**League of Women Voters of New Mexico (LWVNM) Response to
HOLTEC Environment Report July 30, 2018**

**Subject: LWVNM Response to HOLTEC Environment Report
HI-2167521 7-29-18**

OCD Well Locations

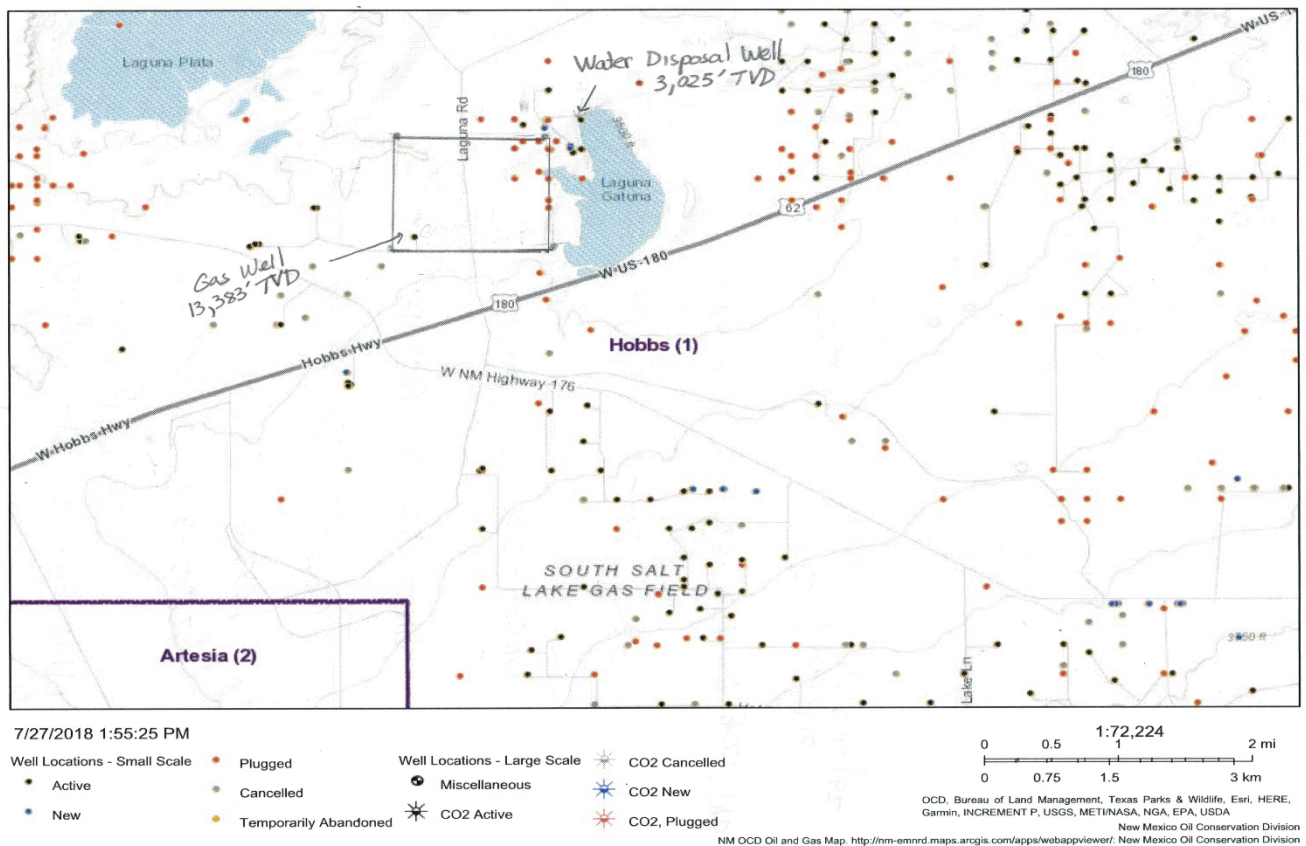
The New Mexico Oil and Gas Division has a website with GIS maps of all oil, gas and water disposal wells in New Mexico – a segment of this map surrounding the Holtec site is shown below.

Holtec doesn’t provide the exact coordinates of the site - the approximate location is shown on the map below, based on the maps in the Holtec report. However, these maps are not clear and they appear to show slightly different boundaries. As Holtec states,

there is a natural gas well within the site boundary. This is a vertical well, 13,383 feet deep, which shouldn't pose a risk to the storage site. However, there would be a gas pipeline from the well to a gas gathering point, which isn't illustrated. Gas pipelines can occasionally leak and possibly explode - proper precautions could prevent this leakage or explosion.

The main concern is a water disposal well located outside the site boundary, which is marked on the map. It is 3,025 feet deep and is operated by Marathon Oil Permian LLC. Water disposal wells are responsible for the earthquakes associated with fracking operations. Holtec does not discuss this well in its report – LWVNM expects this to be addressed.
